2 Revisions to the Preliminary GP and Draft RMP

This chapter presents specific text changes made to the Preliminary General Plan and Draft Resource Management Plan (Preliminary GP/Draft RMP) since its publication on August 27, 2019. California State Parks (CSP) and the U.S. Bureau of Reclamation (Reclamation) carefully considered all comments submitted on the contents and merits of the Preliminary GP/Draft RMP and made a good faith effort to incorporate corrections, clarifications, and appropriate revisions to the GP/RMP consistent with the purpose and need, and objectives of the Preliminary GP/Draft RMP. The information contained within this chapter clarifies and expands on information in the Preliminary GP/Draft RMP and makes minor revisions that are expected to lessen potential environmental effects. None of the changes would result in any new significant effects or substantial increases in previously identified significant effects, so recirculation of the Draft EIR/EIS is not warranted. The latest version of the GP/RMP that was revised in response to comments received in response to the public release of the Preliminary GP/Draft RMP and Draft EIR/EIS is referred to as "revised

Figure 4.4-4 Foresthill Divide Management Zone

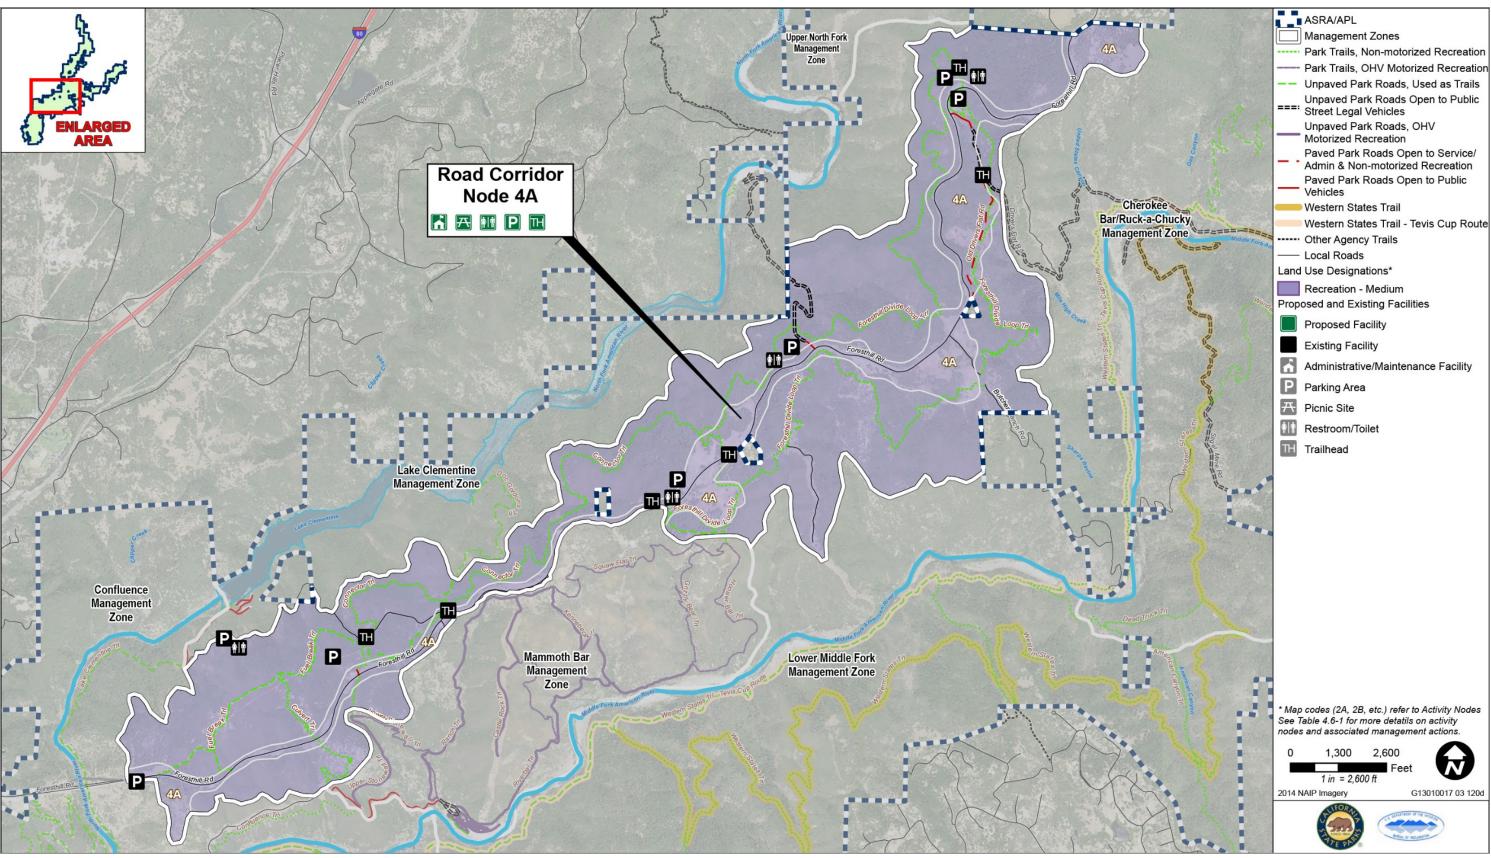
In response to comments requesting fewer campsites, and based on a reasoned estimate of the likelihood for situating camping facilities in the Foresthill Divide Management Zone, Guideline MZ 17.2 on page 4-74 of the Preliminary/Draft RMP has been deleted to remove all proposed campsites and the associated small maintenance yard from this management zone:

Guideline MZ 17.2: Provide a small developed campground with a capacity of up to 20 campsites. And as needed, with a small maintenance yard and equipment storage area of up to 1/4 acre.
